SAFETY RELATED RECALL

Global Recall Action
Number: H520

Subject: Oil Filter Housing Crack	Publication No.: H520
	Model: F-PACE (X761)
	Model Year: 2021 - 2025
	Date of Issue: 15 November 2024

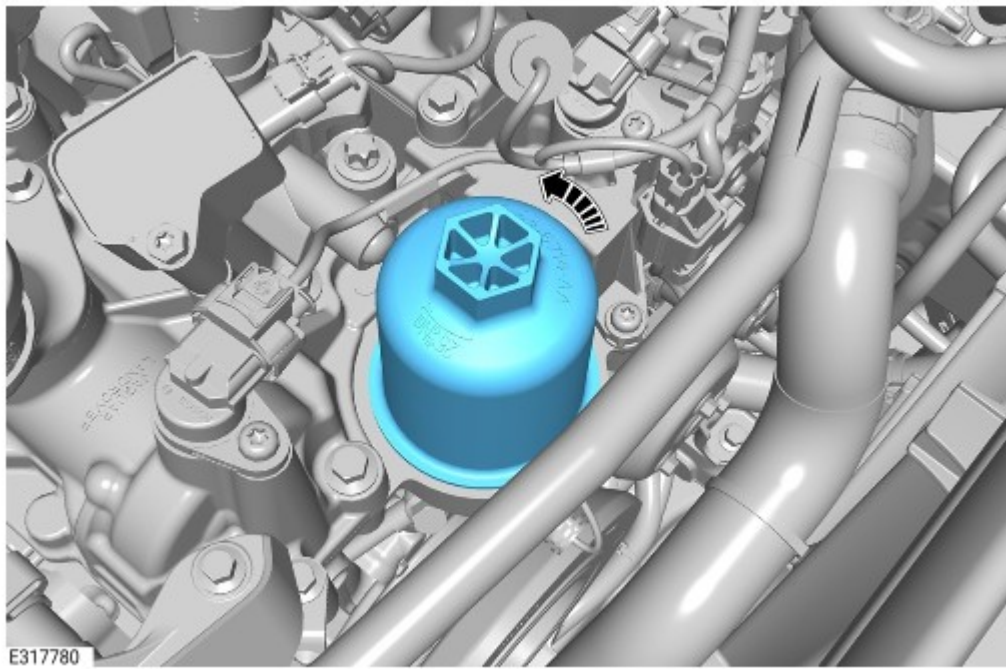
1. Loosen the oil filter element cap 4 complete turns.

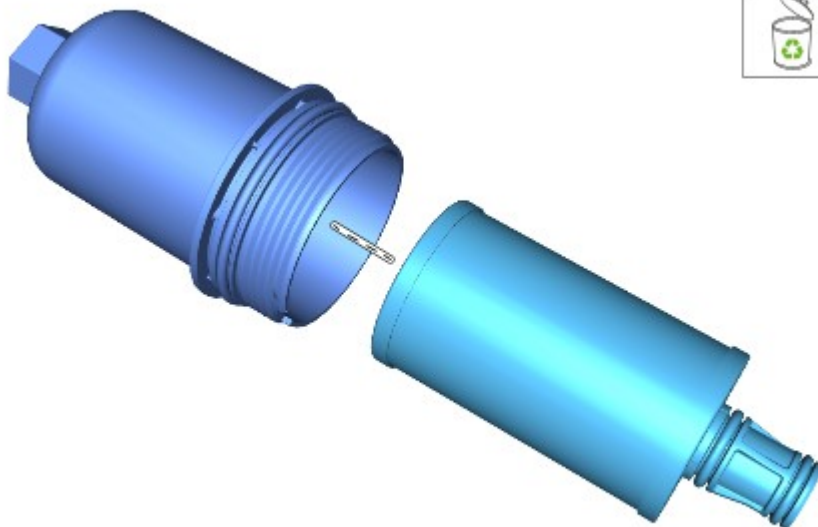
2. Remove and discard the oil filter element cap and the oil filter element.

E363000

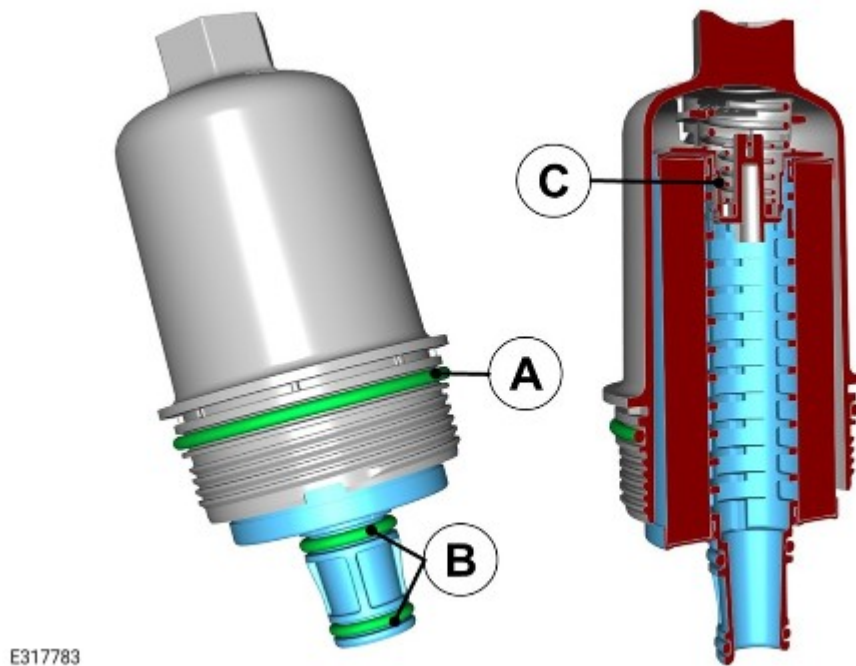
3. Install a new oil filter element. The oil filter element must be pushed correctly onto the bypass valve inside the oil filter element cap (C).

- Lubricate the oil filter element cap O-ring (A) and oil filter element O-ring (B) with clean engine oil.

4. Install and tighten the new oil filter element cap.

- Torque: **25 Nm**
